City of Portland, Oregon
Bureau of Development Services
Land Use Services
FROM CONCEPT TO CONSTRUCTION

NOTICE OF A TYPE II DECISION ON A PROPOSAL IN YOUR NEIGHBORHOOD

CASE FILE NUMBER: LU 18-216393 AD

CASE NO. 19-216393 AD
EXHIBIT C.3

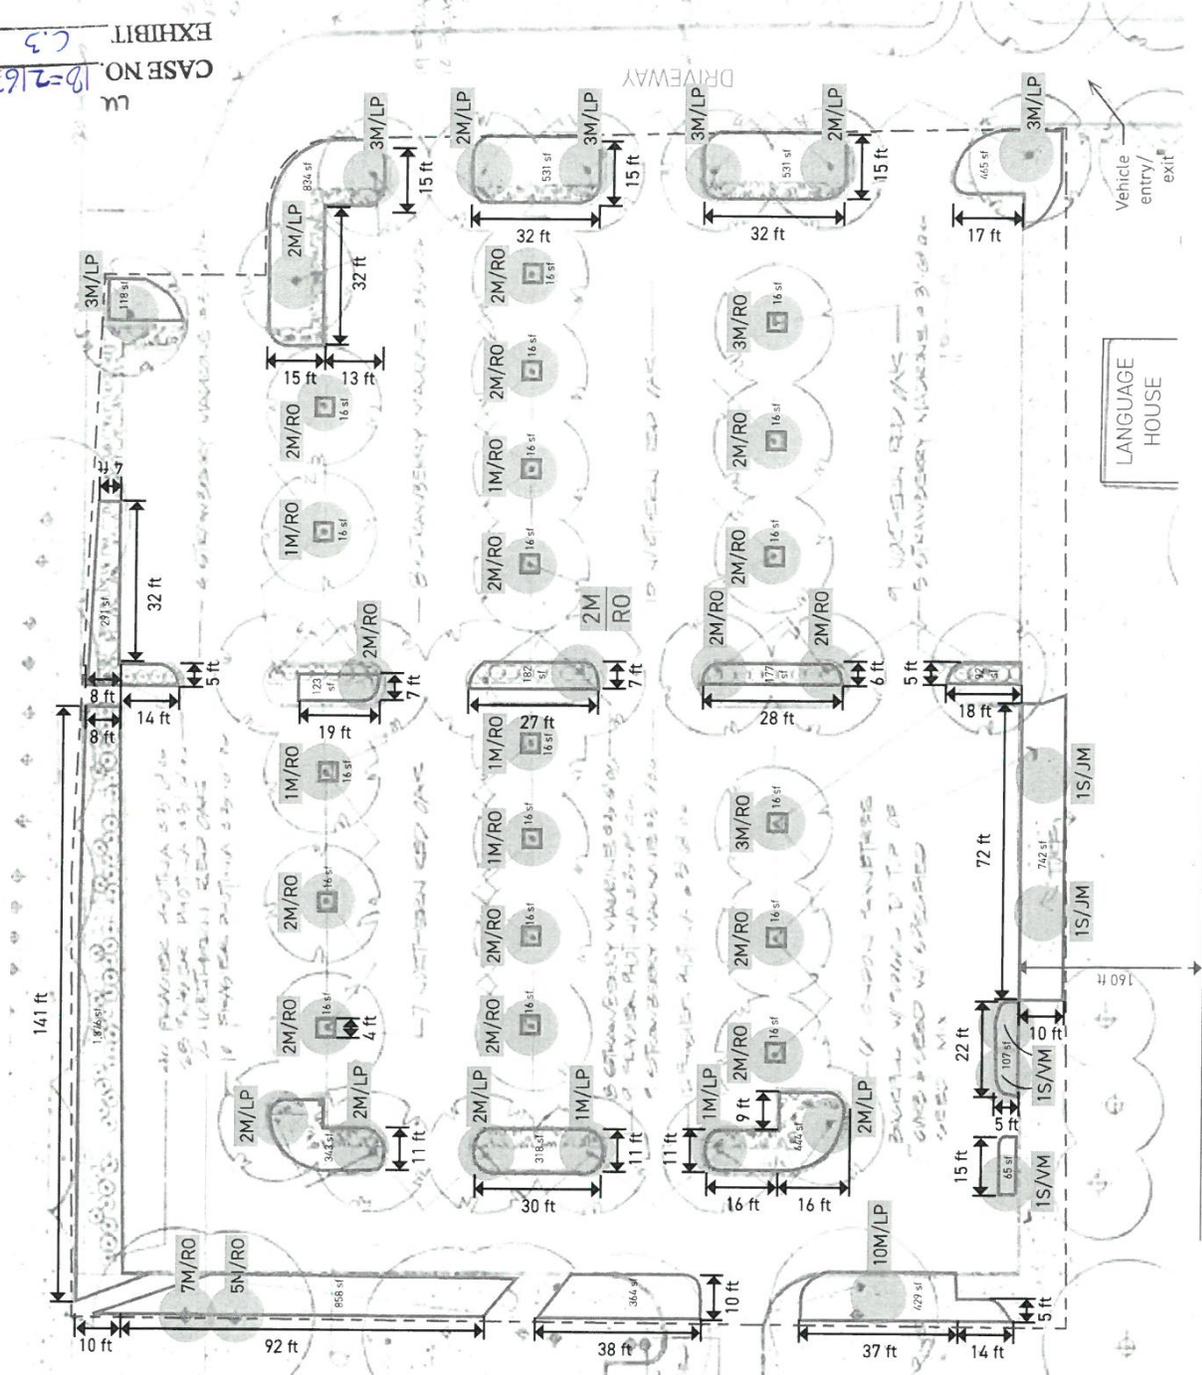
East Parking – This parking area (Exhibit C.3) is set back at its closest point about 160' from SW Woodstock Blvd and several hundred feet from any street or residential zone in all other directions. These setback areas include campus buildings and formal and natural landscaped areas which reduce the visual impacts of the parking area more effectively than would a 5' wide setback landscaped to the L2 or L3 standard. The East Parking Lot also is currently landscaped with dispersed planter islands that include small and medium trees that shade and cool and soften the appearance of the parking area.

EXHIBIT C.5
 CASE NO. 18-216393 AD
 LU

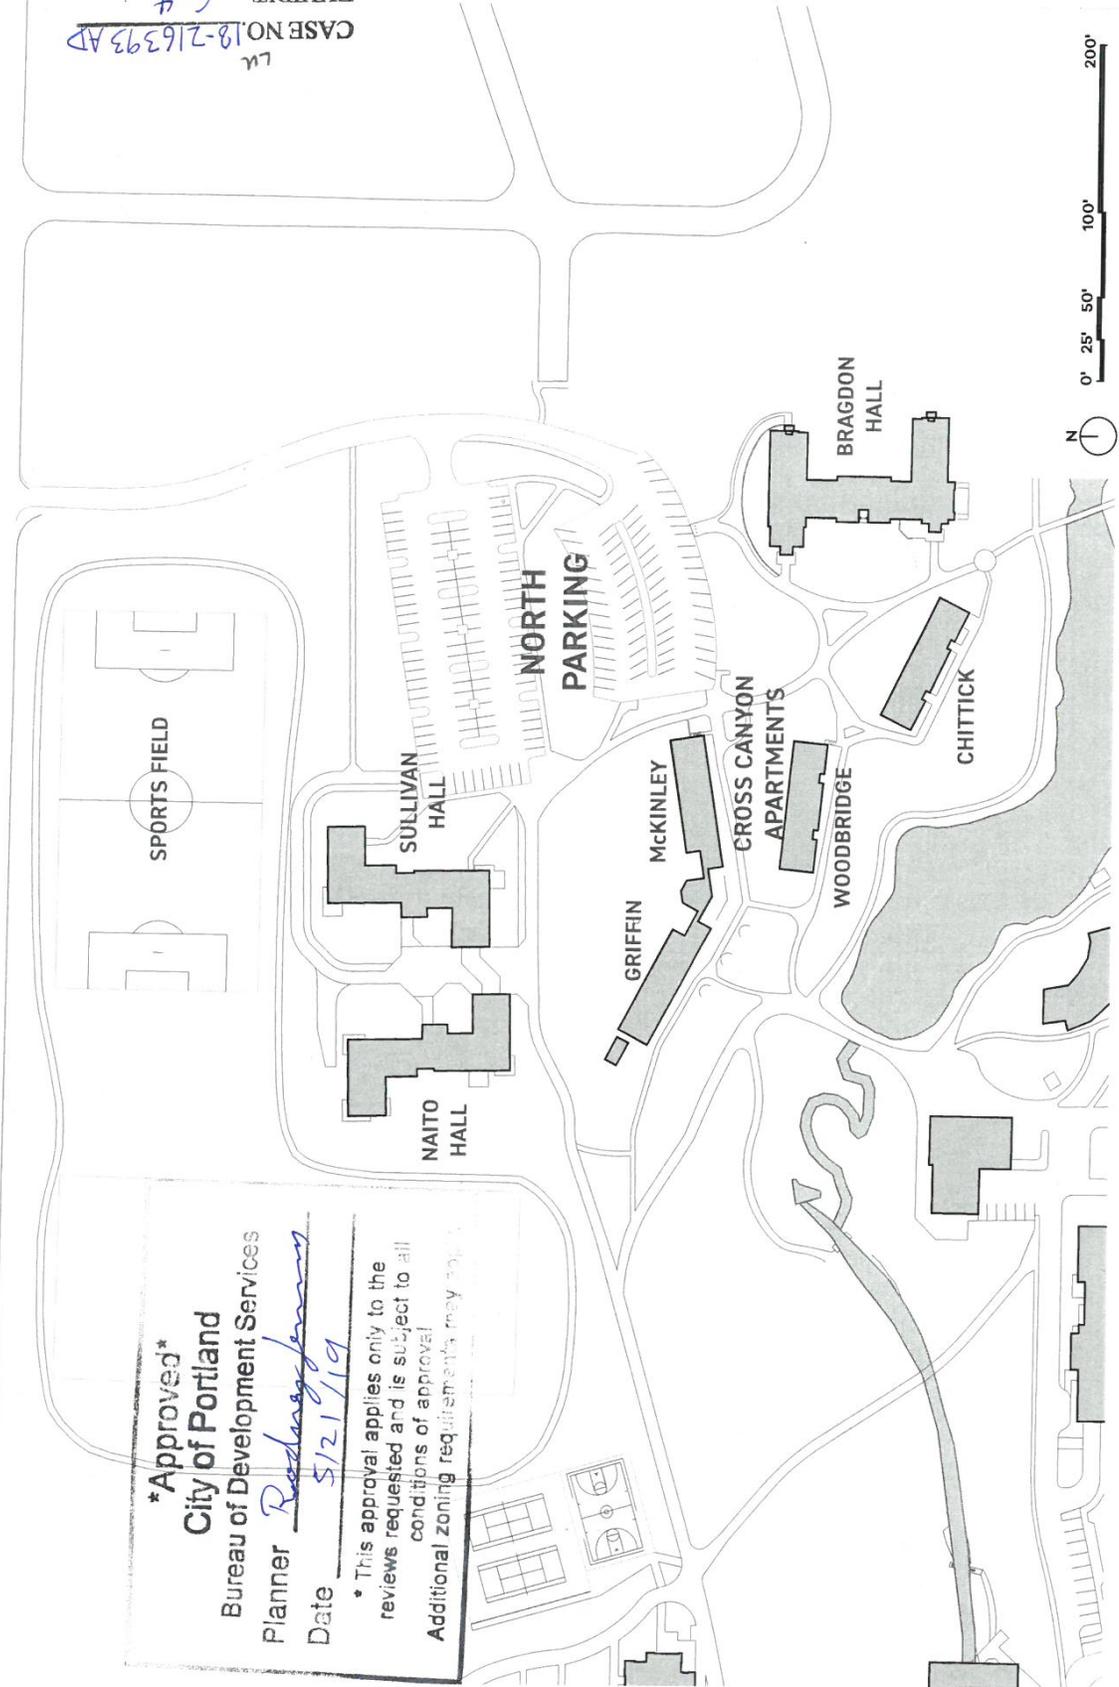
North Parking – This parking area (Exhibit C.5) is set back at its closest point about 75' from the R7 zoned residential area on the east boundary of the Reed College Campus and several hundred feet from any street or residential zone in all other directions. These setback areas include campus buildings and formal and natural landscaped areas which reduce the visual impacts of the parking area more effectively than would a 5' wide setback landscaped to the L2 or L3 standard. The North Parking Lot also is currently landscaped with dispersed planter islands that include small and medium trees that shade and cool and soften the appearance of the parking area.

CASE NO. 18-216393 AD
EXHIBIT C.10

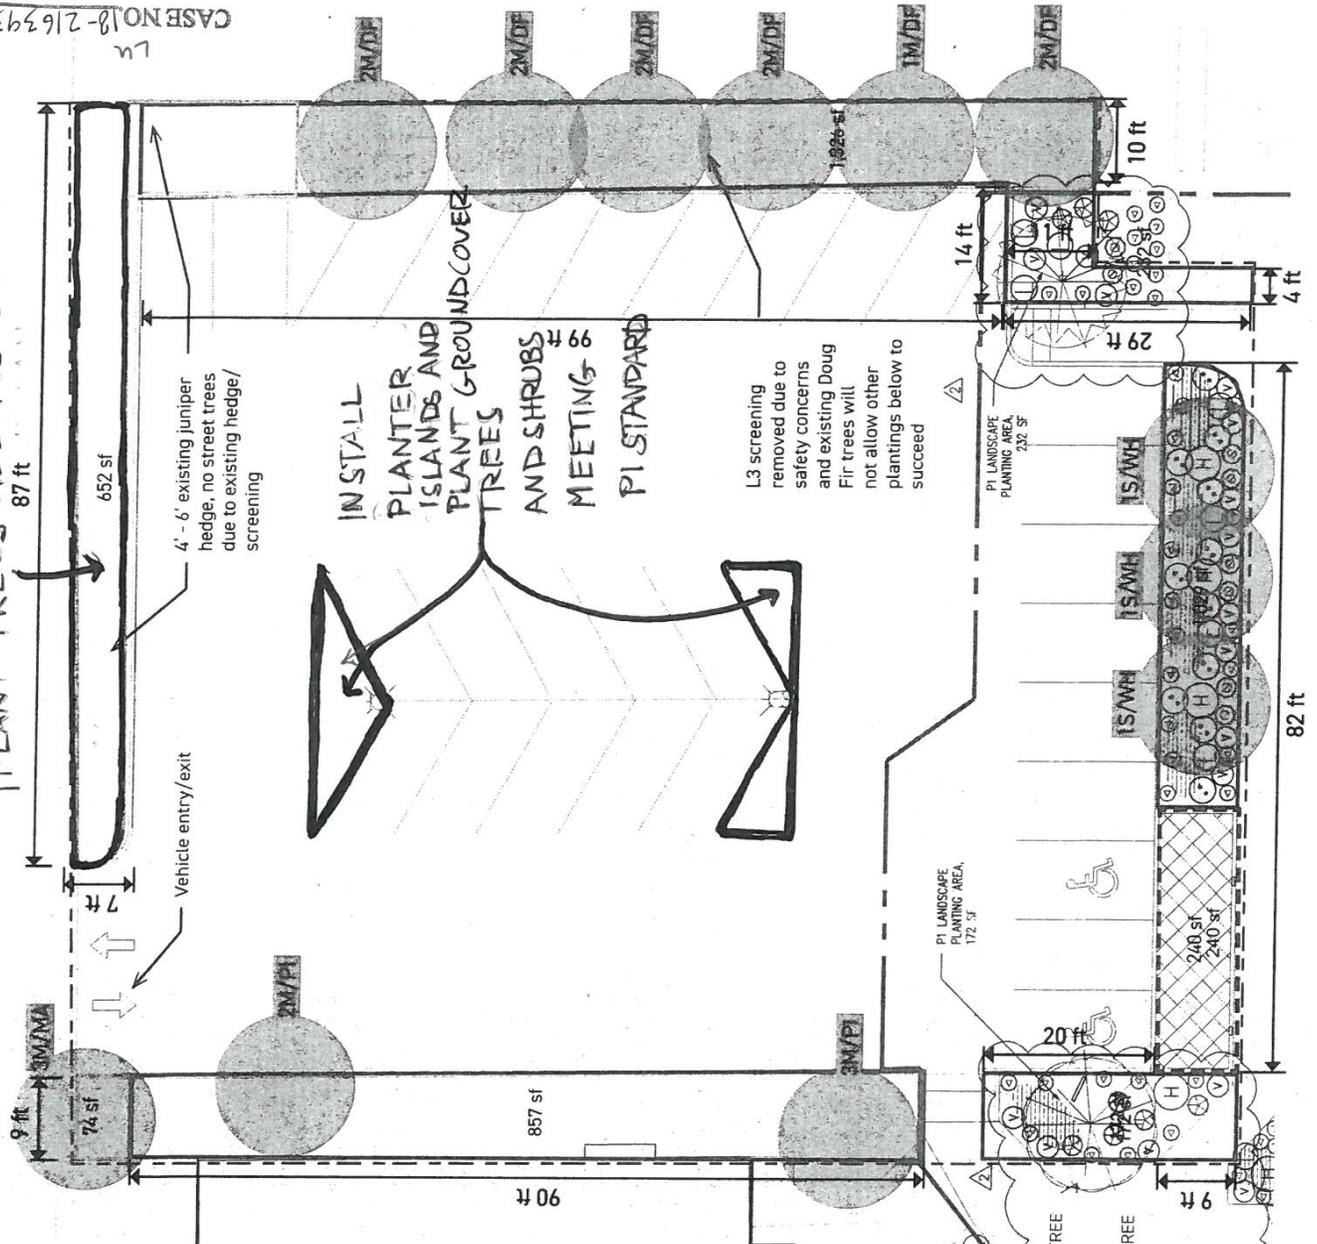
Child Care Parking – This parking area (Exhibit C.10) is located 7' south of SE Steele Street. The parking area is located west of the Child Care building and is several hundred feet from any other streets or residential zones to the east or south. These setback areas to the south and west include campus buildings and formal and natural landscaped areas which reduce the visual impacts of the parking area more effectively than would a 5' wide setback landscaped to the L2 or L3 standard. There is currently substandard perimeter landscaping between the parking area and SE Steele St and limited interior landscaping. Thus, the existing landscaping does not provide the benefits of improving and softening the appearance of the parking area, reducing the visual impact of the parking area from the SE Steele St sidewalk, or shading and cooling the parking areas. The addition of landscaping in the parking area would achieve these purposes. Along SE Steele Street, the existing landscaping within the 7' setback consists of low shrubs. Adding trees to this strip sufficient to meet the L2 standard of 1 small tree for each 15 feet of landscape strip length, one medium tree for each 22 feet, or one large trees for each 30 feet would meet the

purpose of reducing the visual impact of the parking from the sidewalk and would also help to meet the purposes of softening the appearance and shading and cooling the parking area. In addition, adding more landscaping within the interior of the parking area would soften the appearance and add trees to shade and cool the parking area. With a condition that trees meeting the L2 standard be planted in the existing perimeter landscape setback along SE Steele St and that two planter islands be planted with landscaping meeting the P1 standard and at least one medium tree in each island as shown in Exhibit C.10, all purposes of the adjusted standard will be equally or better met for the Child Care parking area.

- B. In the Childcare parking area as shown in Exhibit C.10, enough small, medium or large trees must be planted within the 7' wide landscape strip between the parking area and SE Steele St to meet the tree requirement of the L2 landscape standard; and two new interior landscape islands must be established and landscaped to meet the P1 landscape standard.

INSTALL
PLANTER
ISLANDS AND
PLANT GROUND COVER
TREES
AND SHRUBS
MEETING
PI STANDARD

L3 screening removed due to safety concerns and existing Doug Fir trees will not allow other plantings below to succeed

NORTHWEST PARKING BIRCHWOOD PARKING LOT

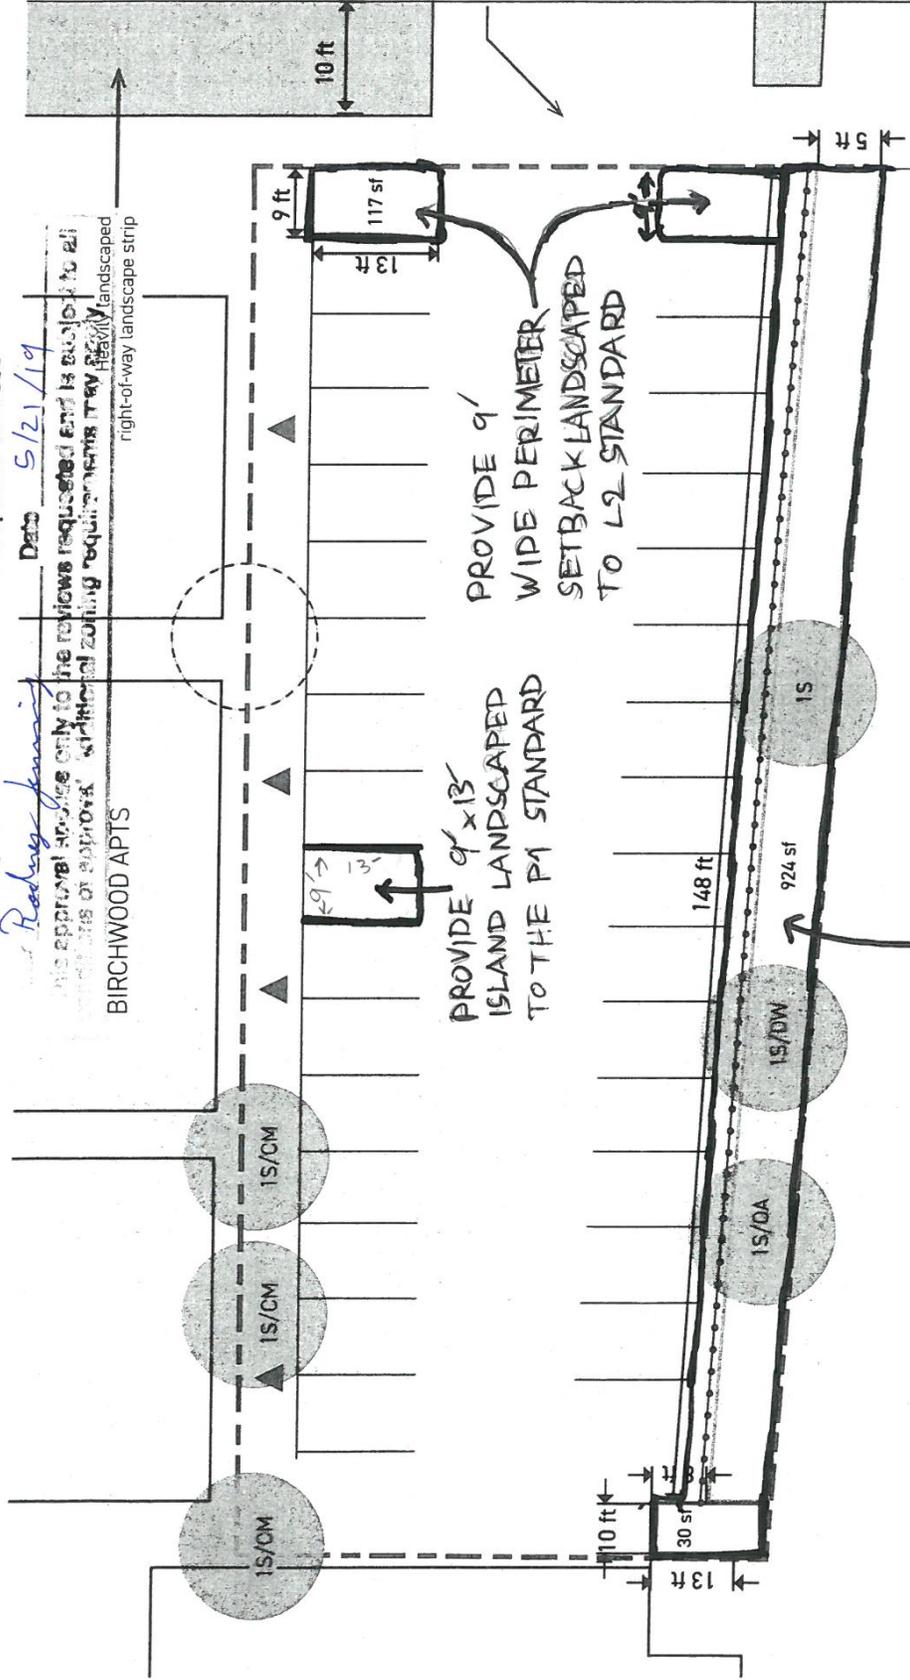
Birchwood Parking, Theatre Annex Parking – These two adjacent parking areas are located on the west edge of the Reed College campus, on the west side of SE 28th Ave (Exhibits C.14 and C.15). Neither parking area abuts a residential zone. Both parking areas currently provide no perimeter landscaping between the vehicle area and SE 28th Ave and provide limited interior landscaping. Thus, the existing landscaping does not provide the benefits of improving and softening the appearance of the parking areas, reducing the visual impact of parking areas from sidewalks, streets or shading and cooling the parking areas. The addition of landscaping in these parking areas would achieve these purposes. Along the SE 28th Ave street frontage of both parking areas, the purpose of reducing the visual impact of the parking areas from the sidewalk and the street can be met by providing a 9' wide landscape buffer meeting the L2 landscape standard as shown on Exhibits C.14 and C.15. Also, adding this perimeter landscaping along with additional interior landscaping would shade and soften the appearance of the parking areas. This can be achieved by planting additional groundcover, trees and shrubs in the landscape strip that separates the Birchwood Parking area from the Theater Annex area and by providing a landscape island in the north row of parking in the Birchwood lot. There are currently 3 small trees planted in the 148-foot long strip between the parking areas. The L2 standard requires three foot high shrubs forming a full screen, at least 1 small tree each 15 feet, one medium tree each 22 feet, or one large tree each 30 feet and groundcover. Upgrading the strip between the two lots with sufficient trees, shrubs and groundcover to meet the L2 standard will provide the additional trees to shade and soften the appearance of both the Birchwood and Theater Annex parking areas. Providing a landscape island in the north row of the Birchwood lot that meets the P1 standard and provides a tree will do the same. With a condition requiring that landscaping be provided as shown on Exhibits C.14 and C.15, all purposes will be equally or better met within the Birchwood and Theatre Annex lots.

- D. In the Birchwood parking area, as shown in Exhibit C.14, the 5' wide landscape strip along the south edge of the parking area must be planted to meet the L2 landscape standard; a 9' wide landscape strip must be established between the parking area and SE 28th Ave and planted to the L2 standard; and a new interior landscape island must be established and landscaped with to meet the P1 landscape standard.

PLANT GROUP COVER, TREES AND SHRUBS MEETING L2 STANDARD
